Mullica Township Government Building

Addendum 1: Narrative

4 EXT. THRESHOLD DETAIL
6" = 1'-0"

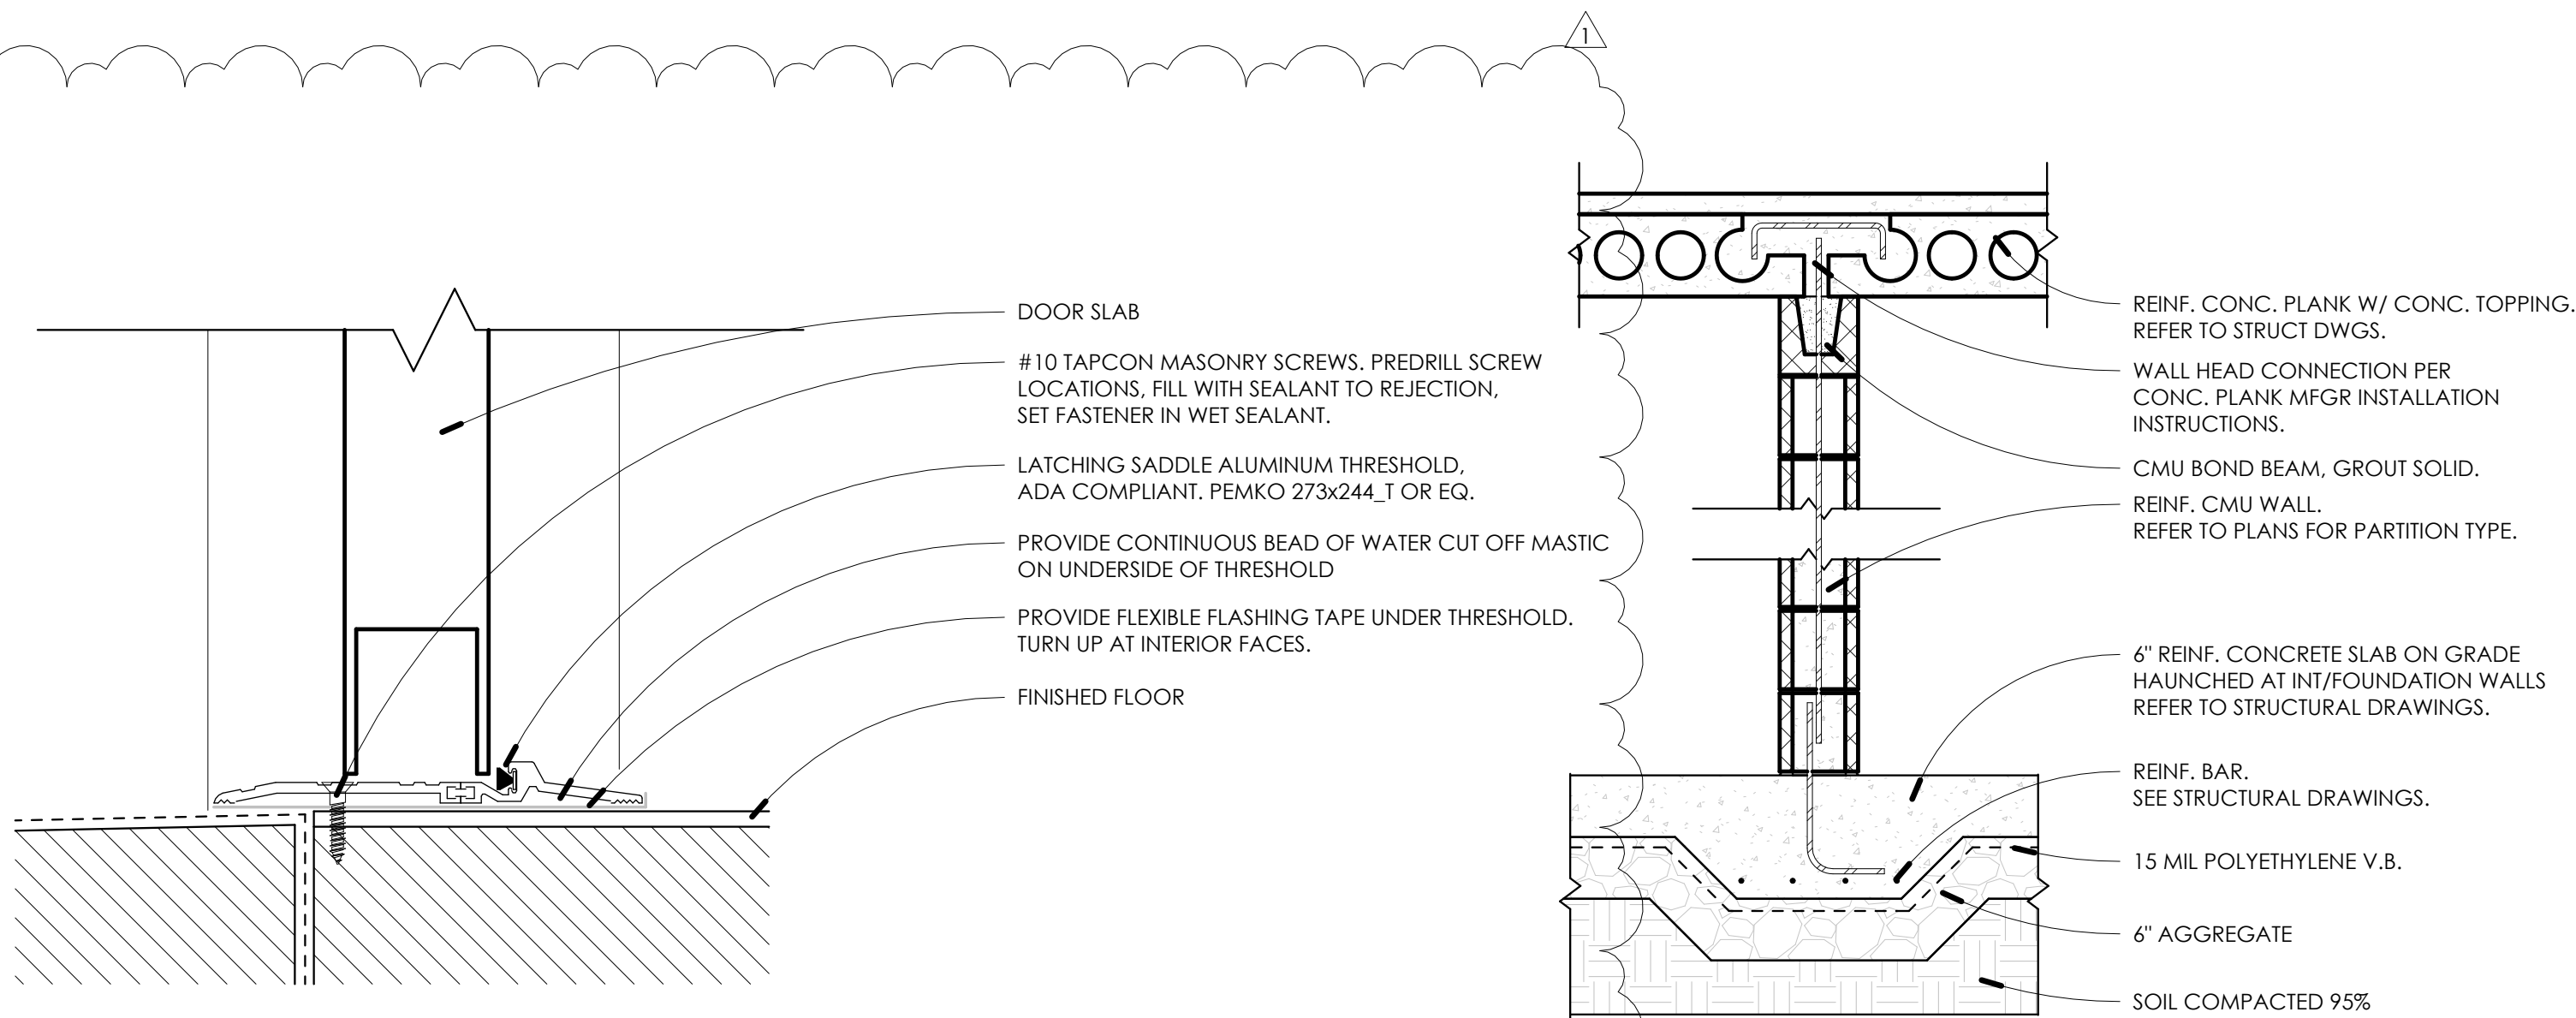
A5.11: Exterior Threshold Detail has been added.

MECHANICAL
DEMOLITION PLANS

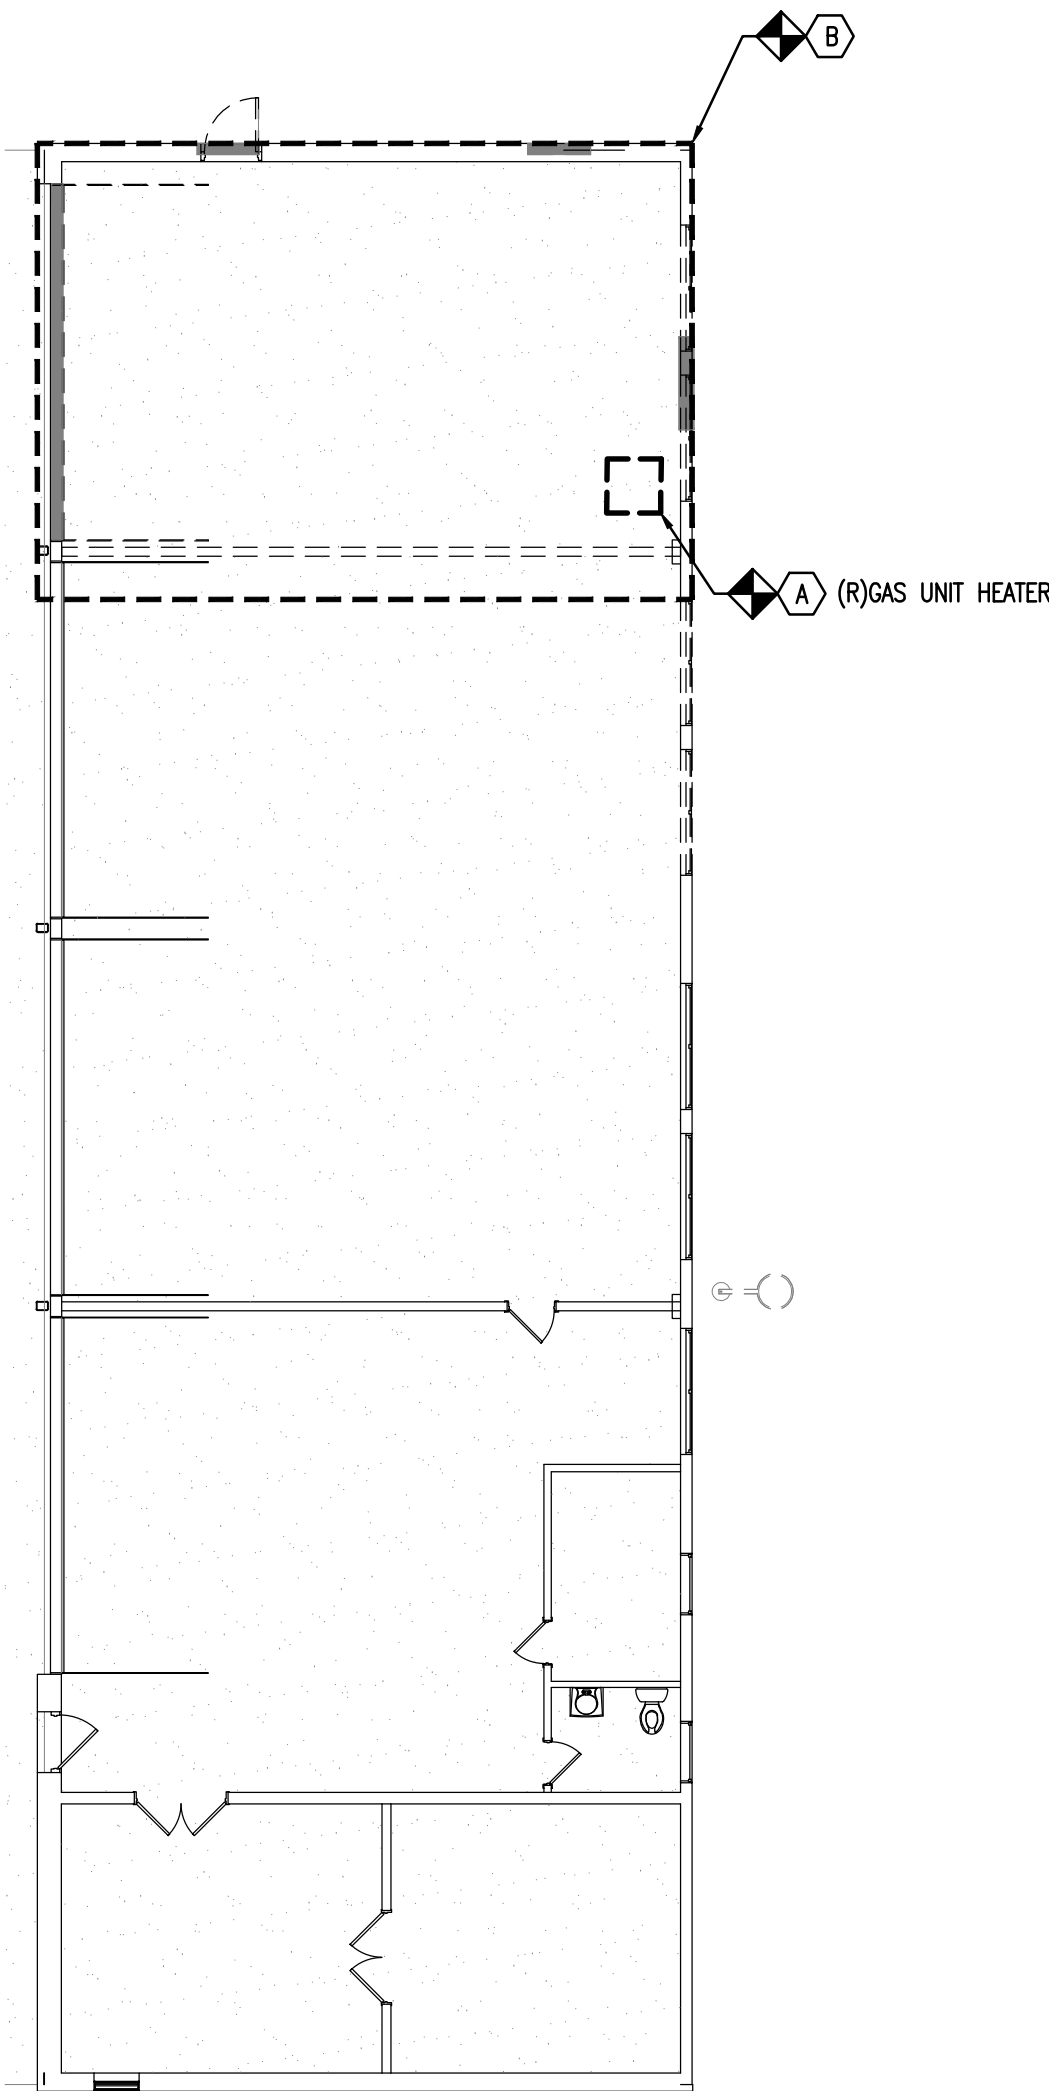
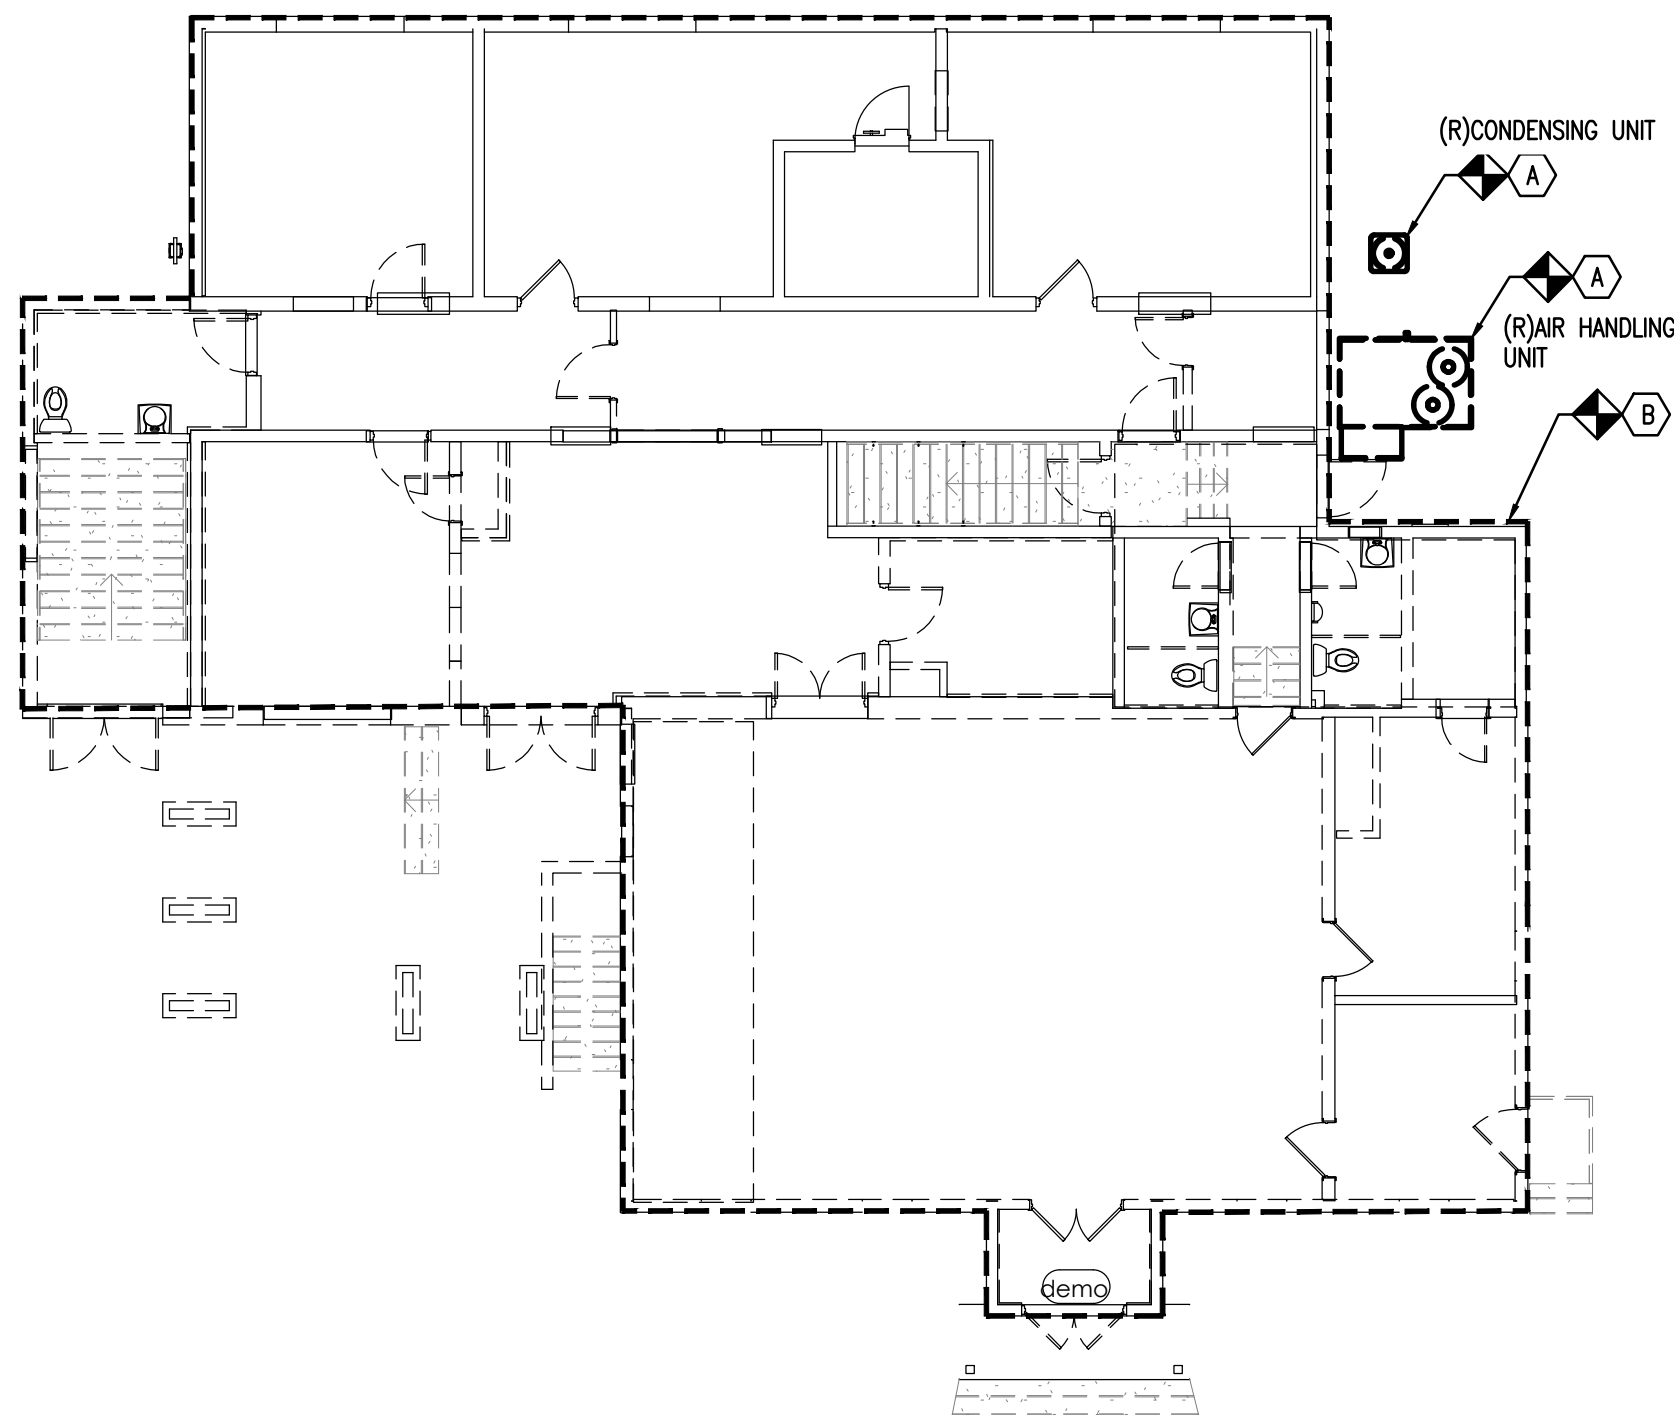
NUMBER	SHEET	QUESTION	DATE RECEIVED	DATE RESPONDED	RESPONSE
042	MD1.01	Please clarify the extent of the mechanical ductwork and piping demolition noted on drawing MD1.01 note 'B'.	07.20.26	07.24.26	CEG: Refer to MD1.01: Demolition General Note 1C: Contractor to Verify Existing equipment before demolition. Scope of work contains but is not limited to: Existing First Floor Garage: Remove the gas unit heater, vent, gas piping, and power control wiring. Remove power wiring back to electrical panel per NEC guidelines. Patch all roof and wall sections affect by this demolition. Existing First Floor: Within the offices and townhall area, remove the existing GRDs (floor or wall or ceiling) and associated ductwork back to the AHU's being demolished (28x12 Main ducts for offices). Remove vairous exhaust fans, grilles and ductwork. Hydronic piping will need to be removed as well as the fin tube radiators (found throughout the offices). Demolish the control wiring and thermostats. Patch all roof and wall sections affect by this demolition. Existing Basement Floor: Within the offices and basement storage area, remove the existing GRDs and associated ductwork back to the AHU's being demolished (20x8 Main ducts for office and storage rooms) Hydronic piping will need to be removed as well as the fin tube radiators (found throughout the offices). Note that most of the hydronic piping is fed throughout the building in the ceiling of the basement. Main sizes are 1-1/4" Supply and Return. The boiler system will be removed completely along with any expansion tanks and pumps. Cap the domestic water feed per NSPC. Demolish the power and control wiring and thermostats. Remove power wiring back to electrical panel per NEC guidelines.
